TRUCK, CARGO, LIGHT, MC2, LAND ROVER 110 6X6 - ALL TYPES

REPLACEMENT OF THE REAR AND INTERMEDIATE AXLE REBOUND STRAP
RETAINING CLIPS AND REWORK OF THE BRAKE PIPE PROTECTOR PLATE

MODIFICATION INSTRUCTION

FIG 1 - REWORK OF BRAKE PIPE PROTECTOR PLATE AND FITMENT OF "C" SHAPED REBOUND STRAP RETAINER

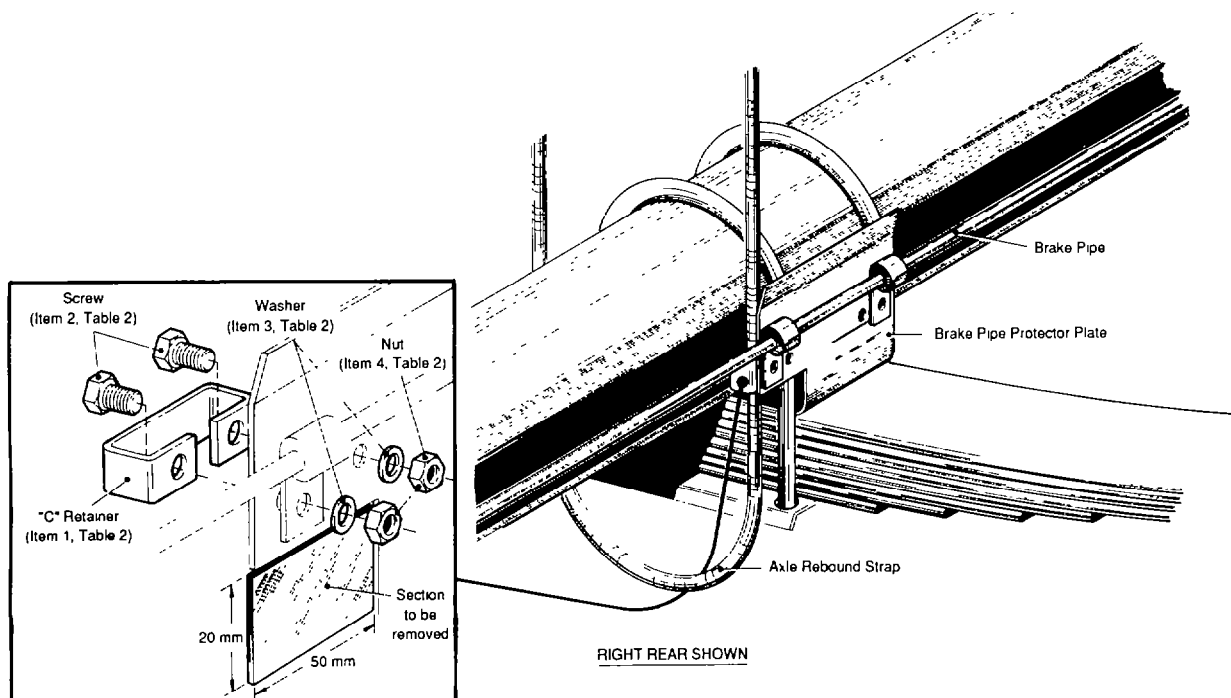
1. This instruction details the replacement of the existing "L" shaped axle rebound strap retention bracket with a "C" shaped retainer which totally encloses the rebound strap. In addition the brake pipe protector plate is also to be reworked to reduce the possibility of it being bent due to impact damage. Some vehicles have had the modified retainers fitted in production but all require the plate to be reworked.

- d. Rework the brake pipe protector plates by cutting a section approximately 50 mm x 20 mm, as shown in Fig 1, ensuring that the retainer clip mounting holes are not cut away.

- e. Attach the "C" retainers (item 1 from Table 1) to the brake pipe protector plates using the existing mounting bolts, washers and nuts and the new mounting screws, washers and nuts (items 2, 3 and 4 from Table 1), as shown in Fig 1.

1. The protector plates can be reworked in situ using a small grinder. If a grinder is not available the spring U bolts will have to be removed and the axles raised to allow the protector plates to be removed for rework and the axles and U bolts refitted, as described in EMEI VEH G 203, paragraphs 190-192.
2. Oxy-Acetylene cutting is not to be used to rework plates on the vehicle.
